Amendments to the Drawings:

REMARKS/ARGUMENTS

Changes in the Drawings:

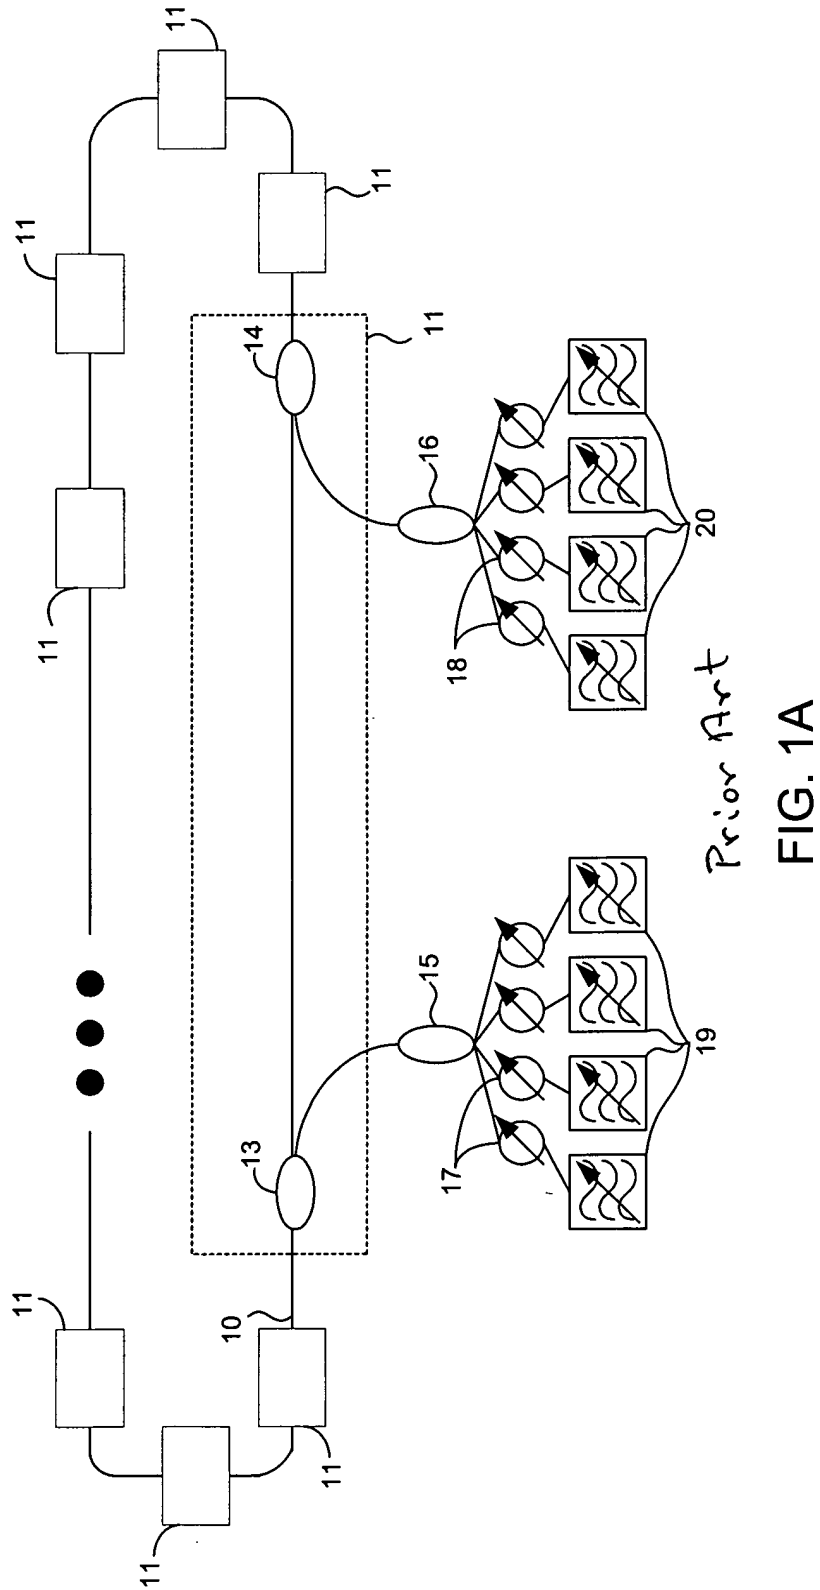
“FIG. 1A” has the phrase, “Prior Art” inserted therein.

FIG. 1B

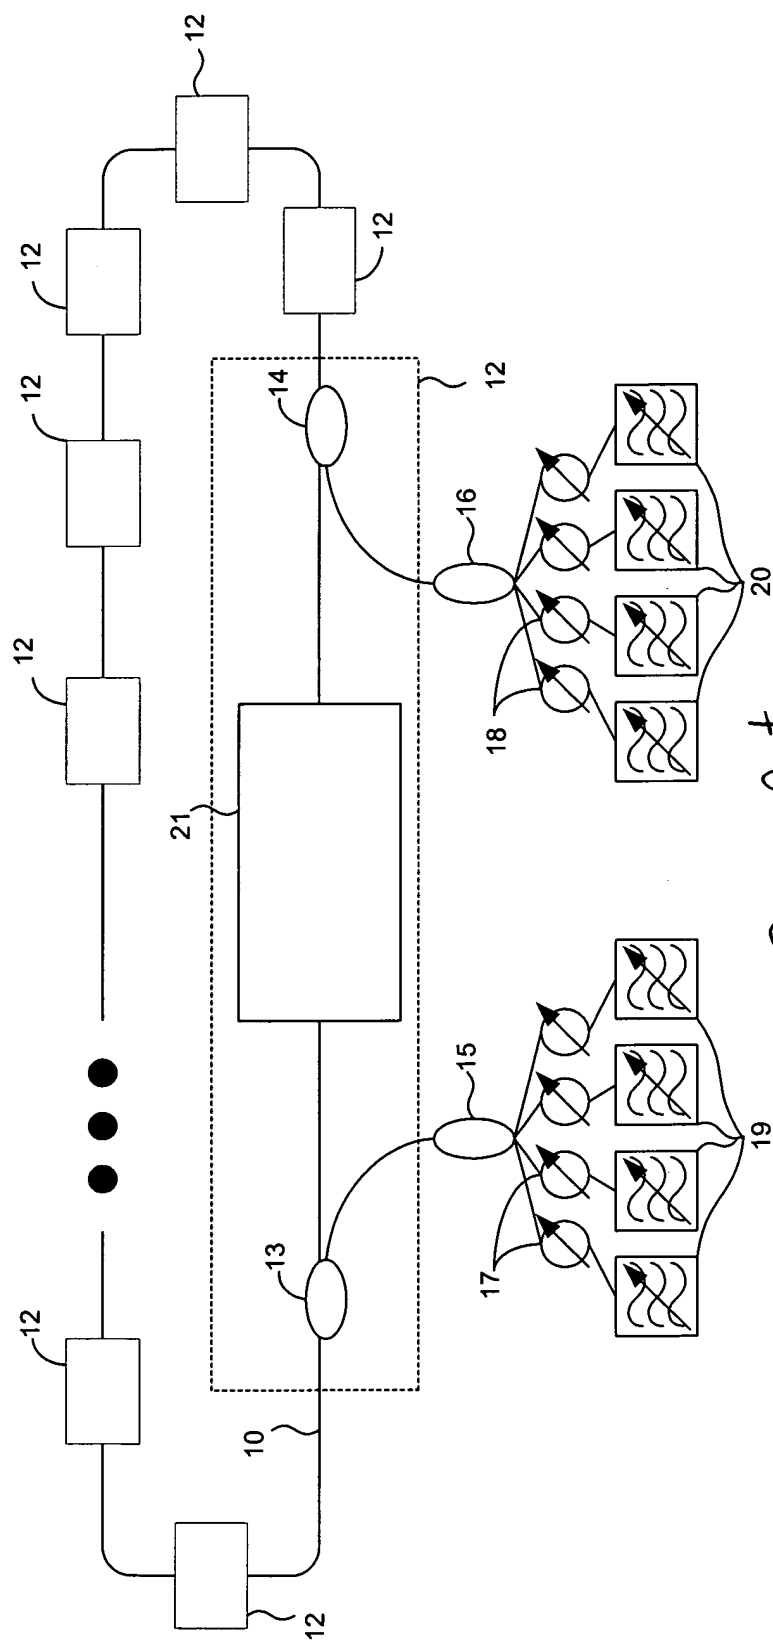
“FIG. 1B” has the phrase, “Prior Art” inserted therein.

Fig. 32

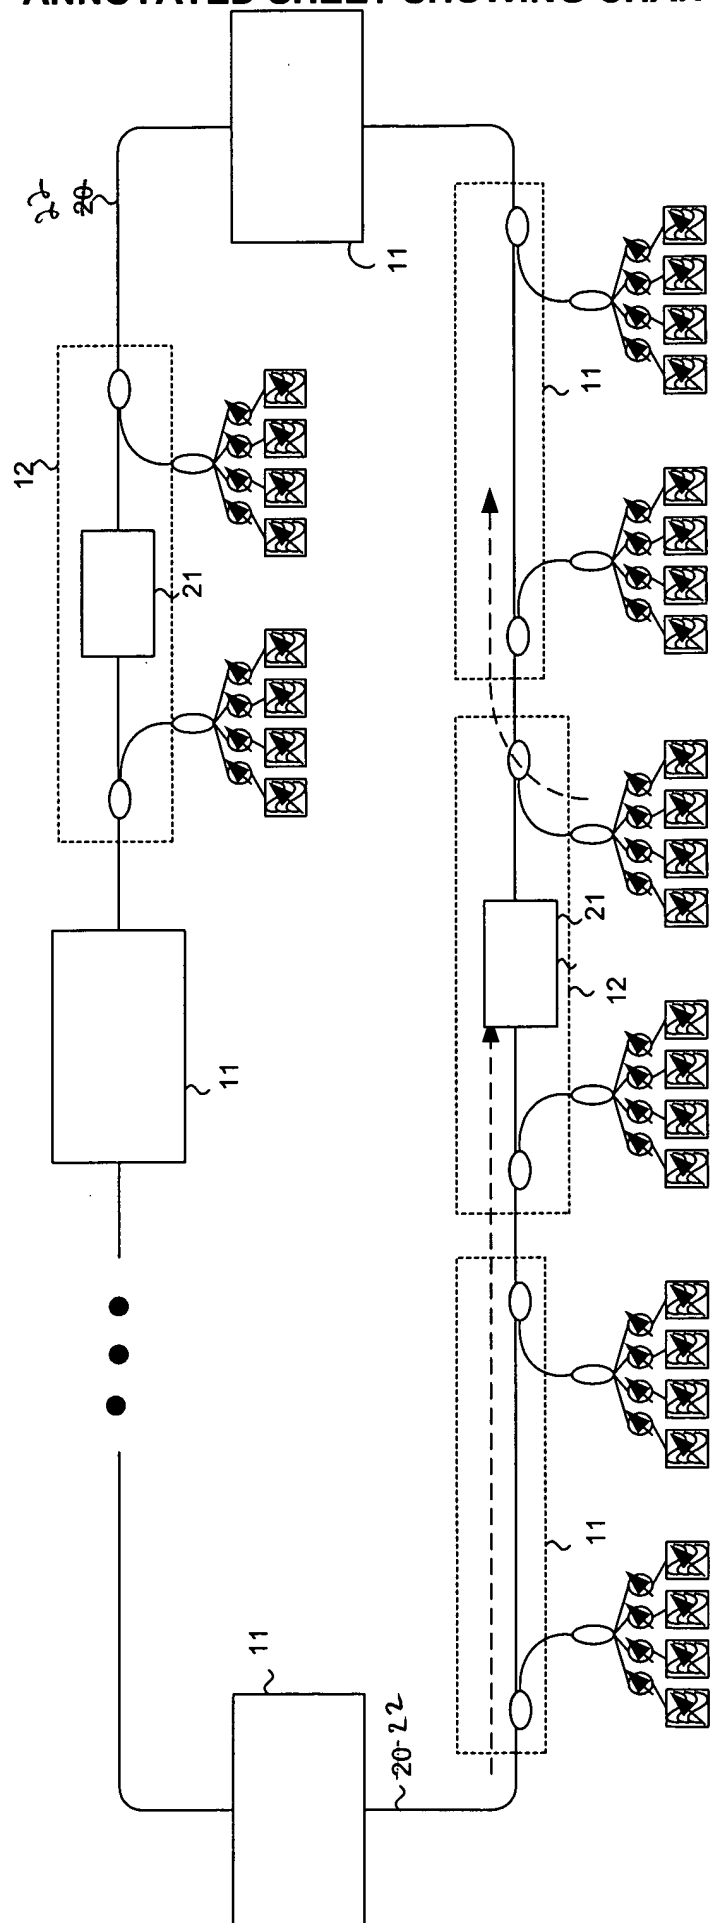
“FIG. 2” has been relabeled “FIG. 3”.

FIG. 23

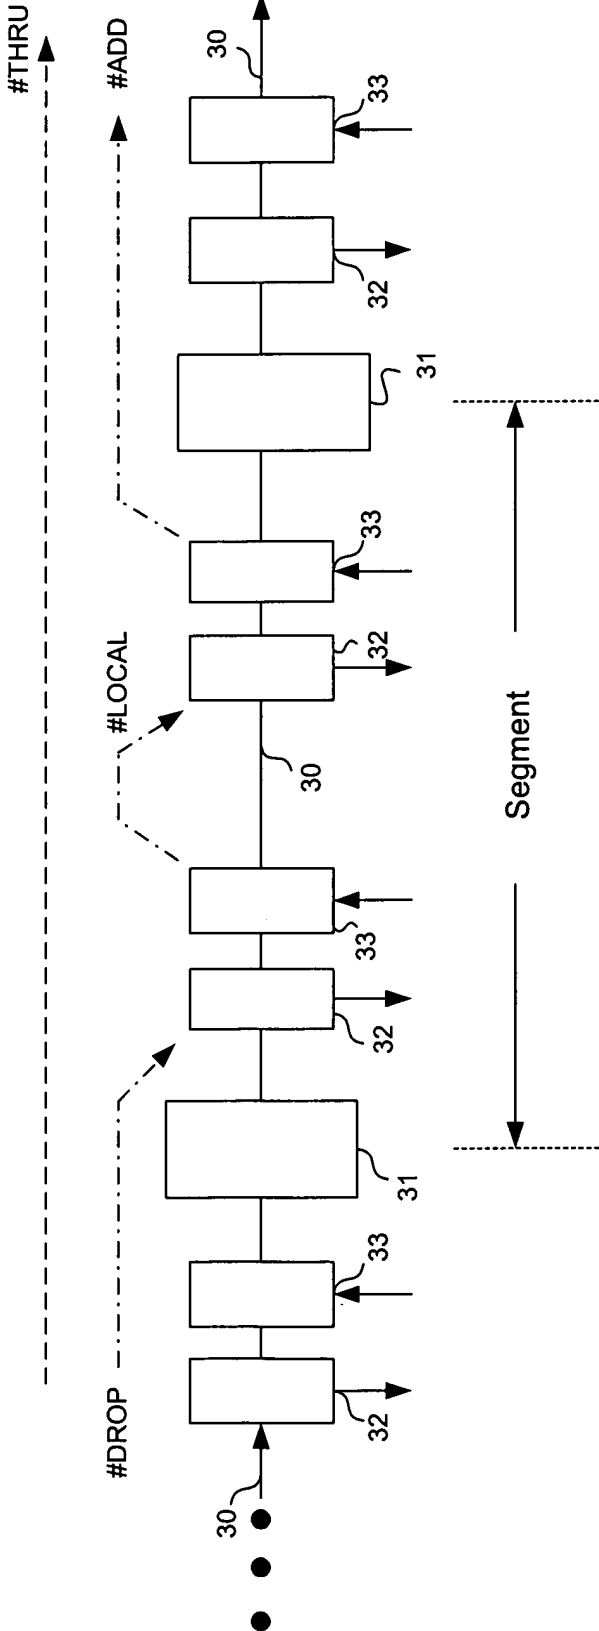
“FIG. 3” has been relabeled “FIG. 2”.

FIG. 5A-4A

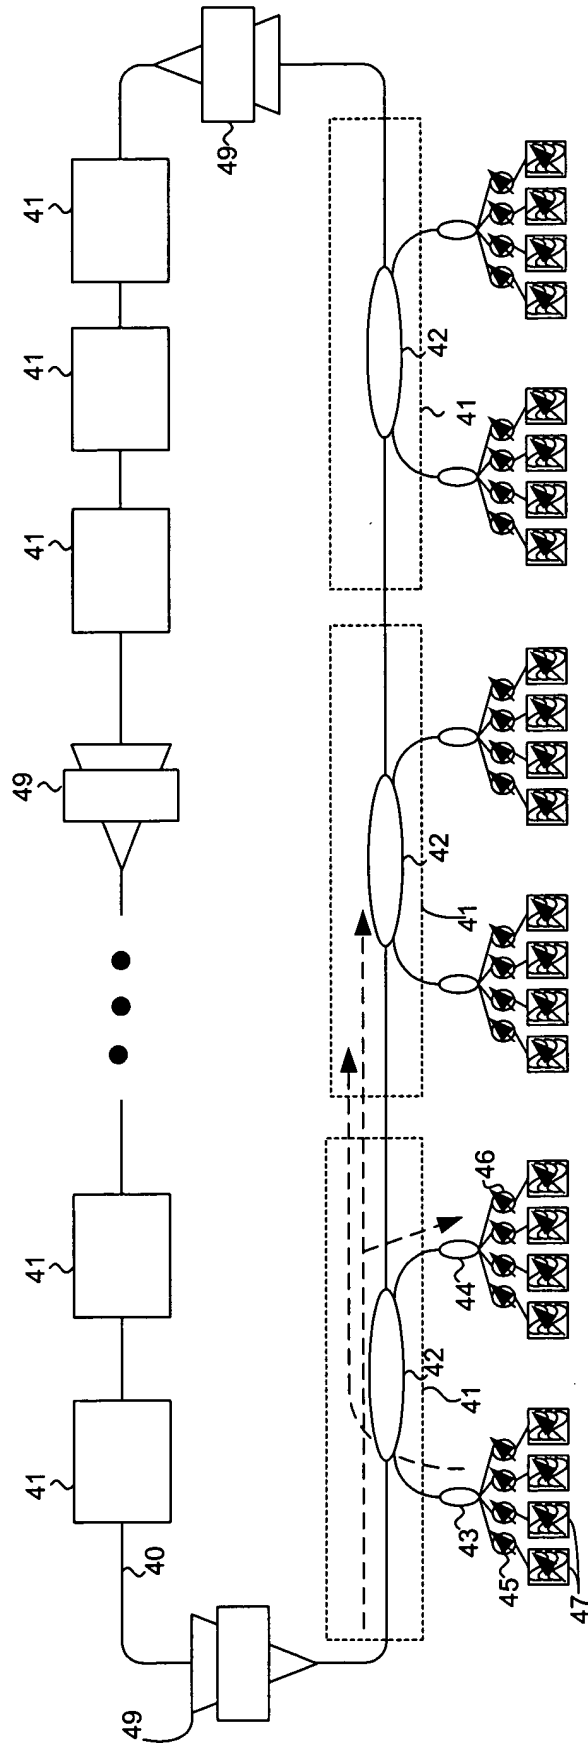
“FIG. 5A” has been relabeled “FIG. 4A”.

FIG. 5B 4B

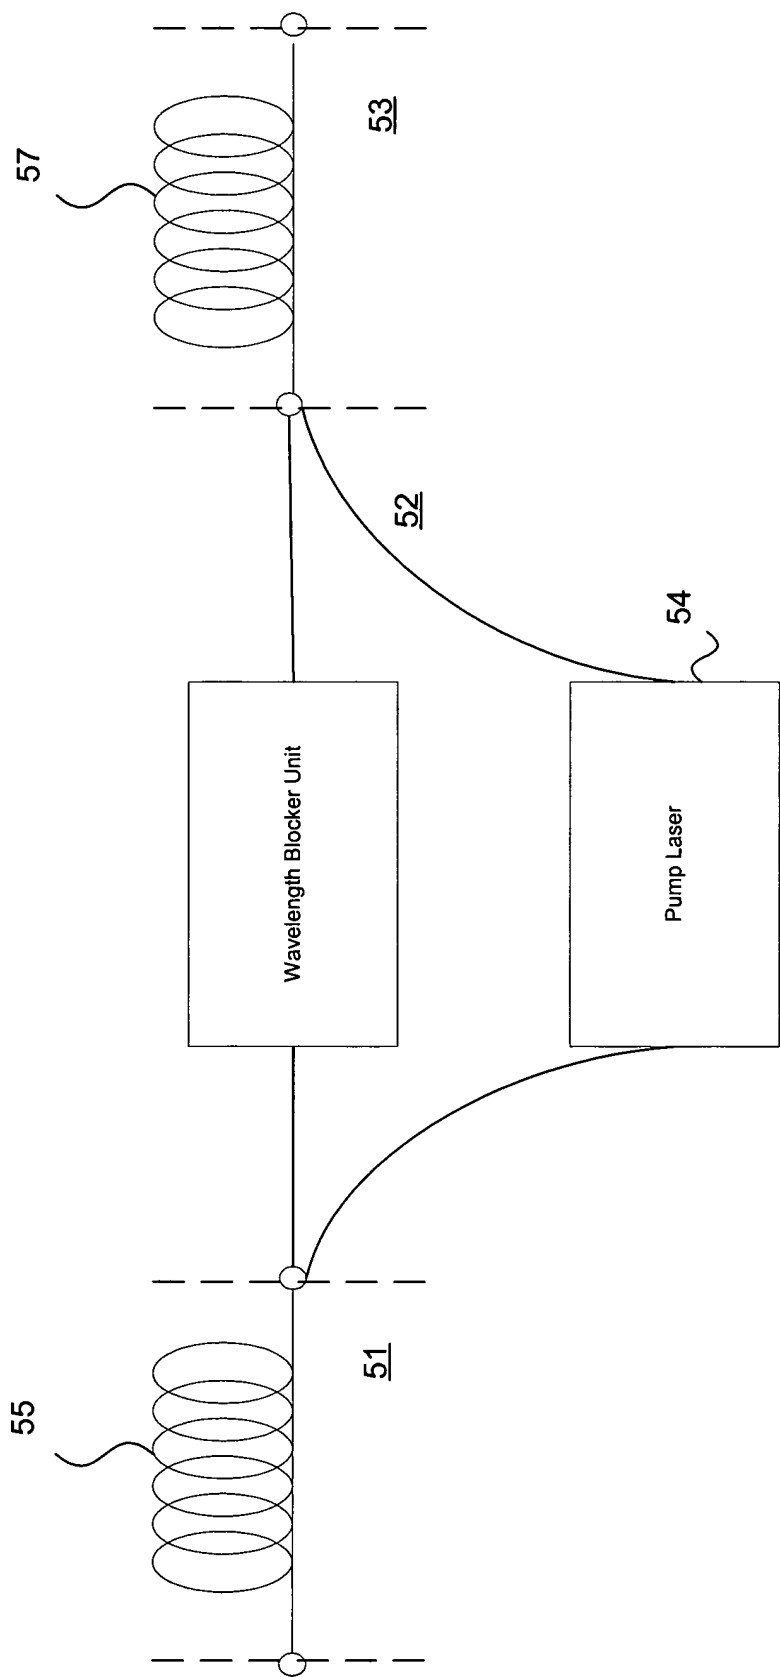
“FIG. 5B” has been relabeled “FIG. 4B”.

FIG. 5

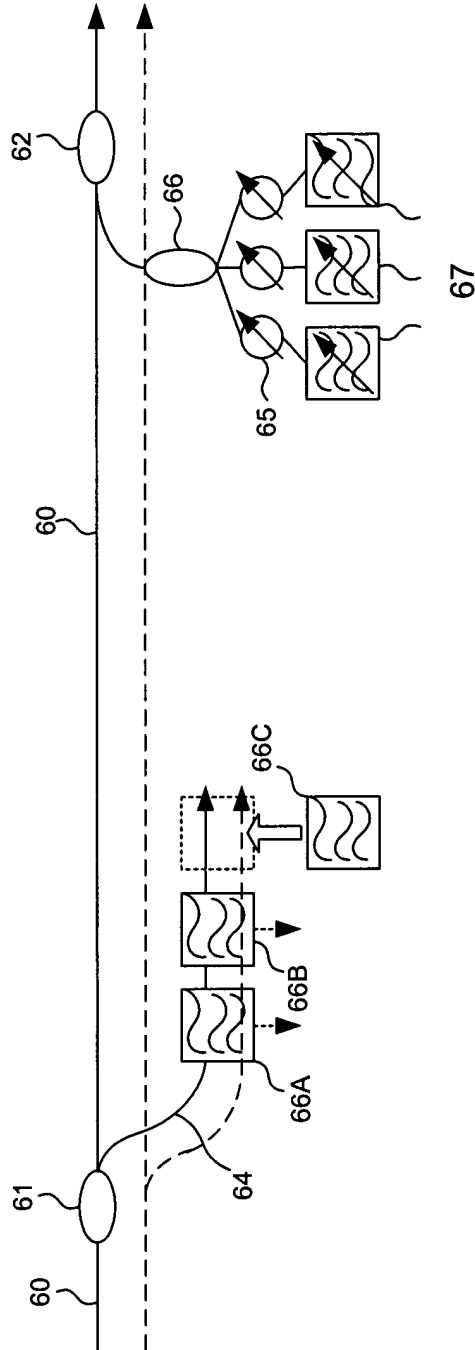
“FIG. 6” has been relabeled “FIG. 5”.

Fig. 4A

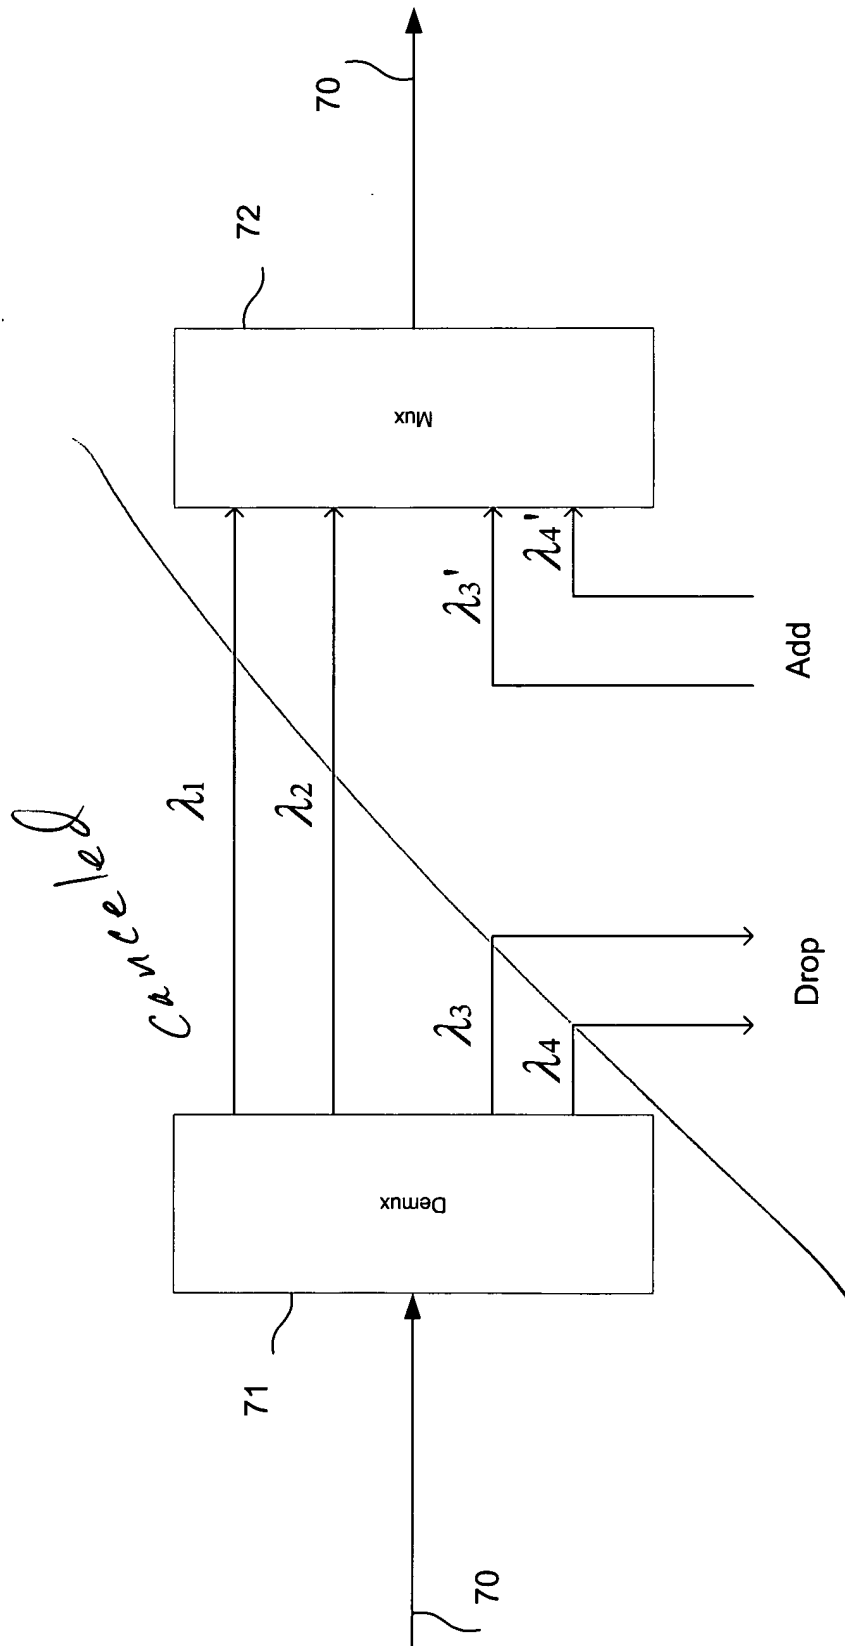
“FIG. 4A” has been canceled.

Fig. 4B

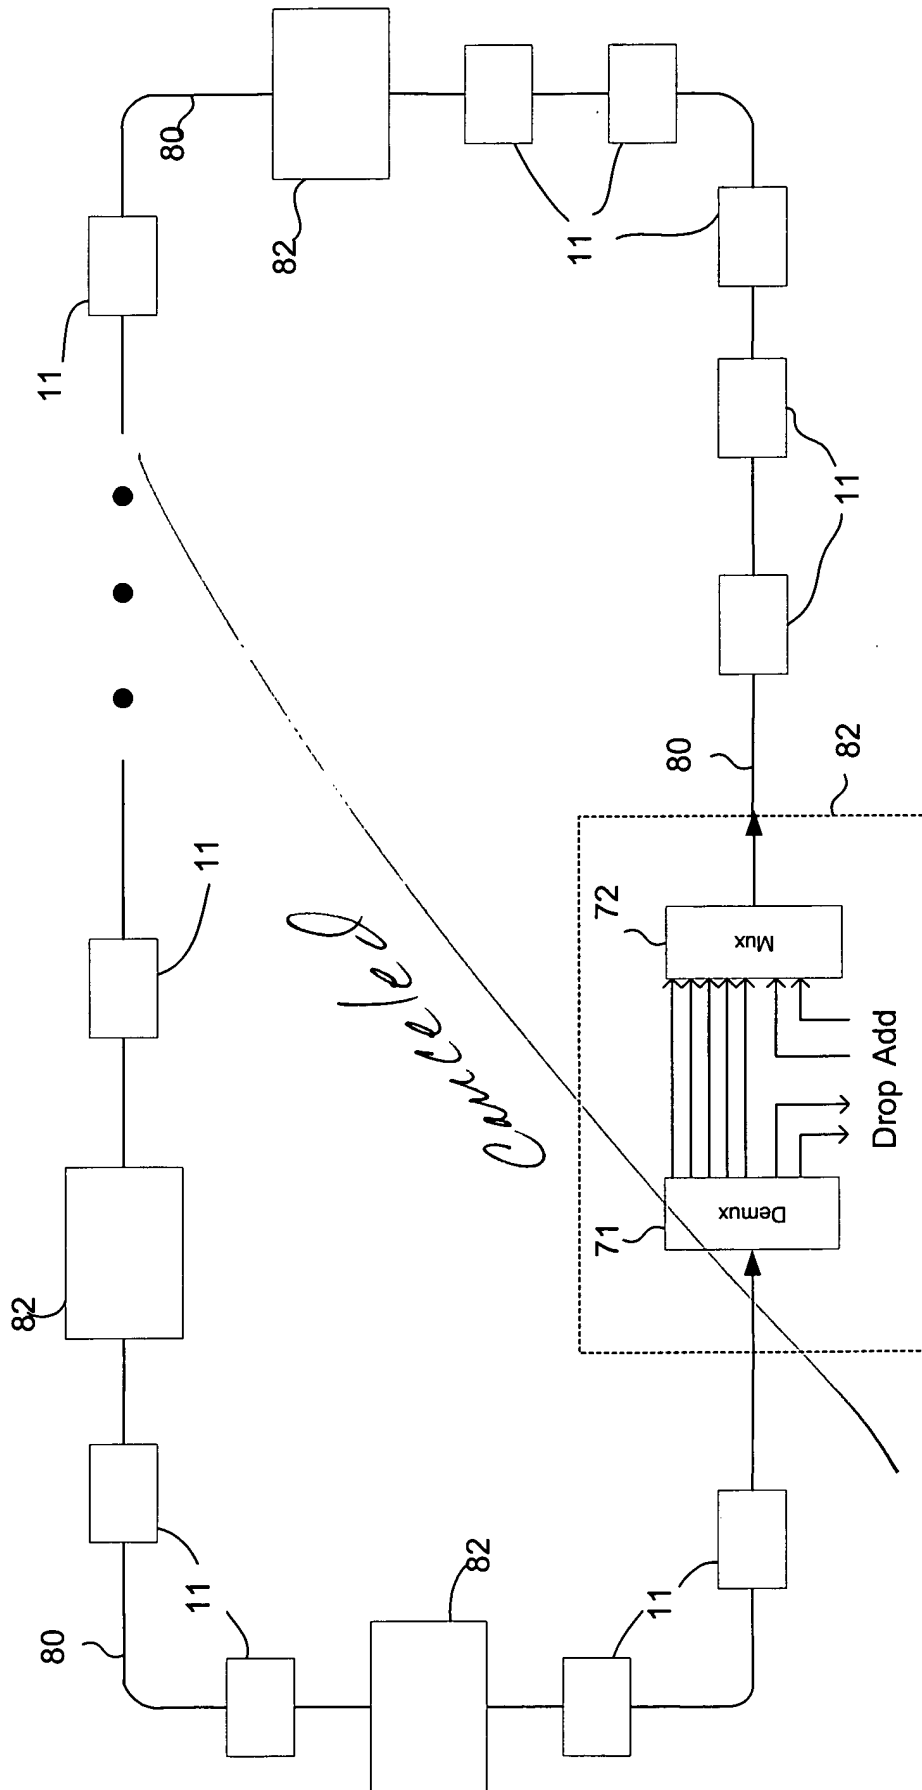
“FIG. 4B” has been canceled.
